California Independent
System Operator Corporation
Dariush Shirmohammadi
Director of Regional Transmission – South
(916) 608-1113

Subject: South Bay Re-Power Generation Final Approval

ATTACHMENT

South Bay Re-power Interconnection

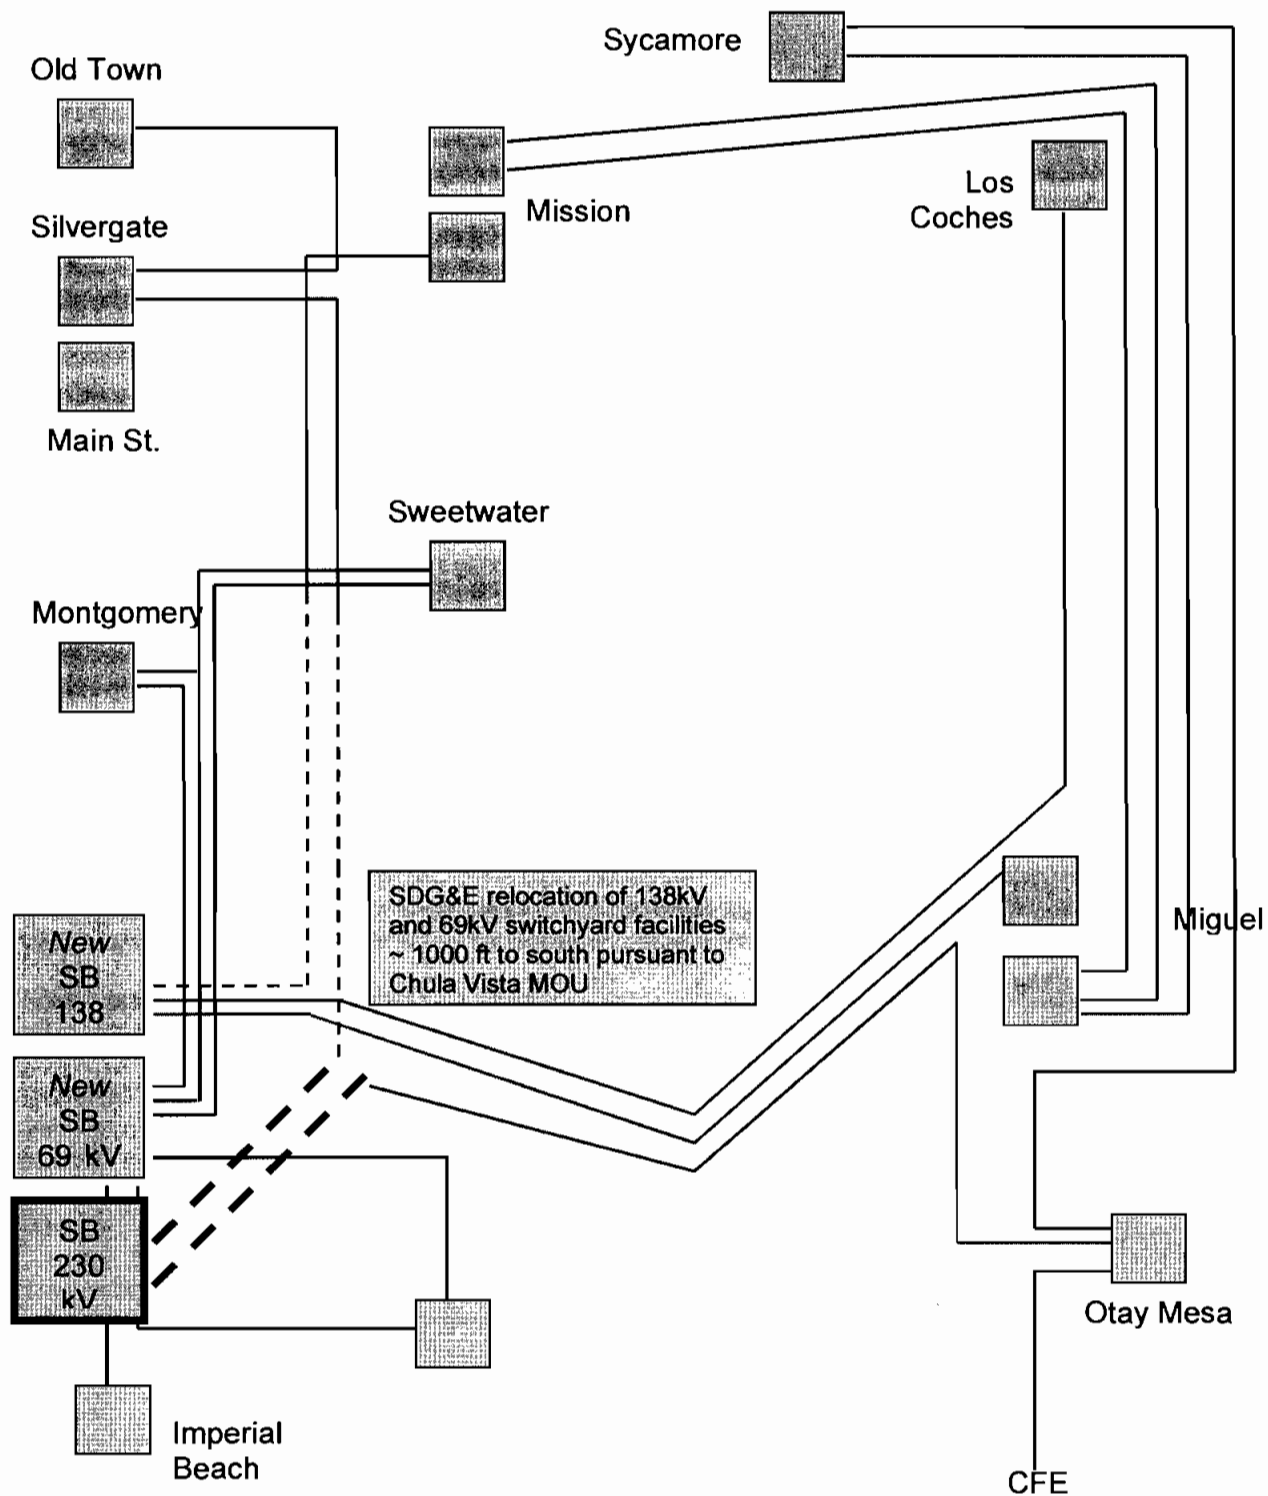
1. The gas turbine generators will be connected: one unit to the 69 kV bus, second unit to the 138 kV bus, and the steam unit will be connected to the 230 kV bus.
2. SDG&E develops a Special Protection System (SPS) to mitigate contingency overload on the Sycamore Canyon-Miguel tap 230 kV transmission line for an outage of the South Bay-Silver Gate 230 kV line.
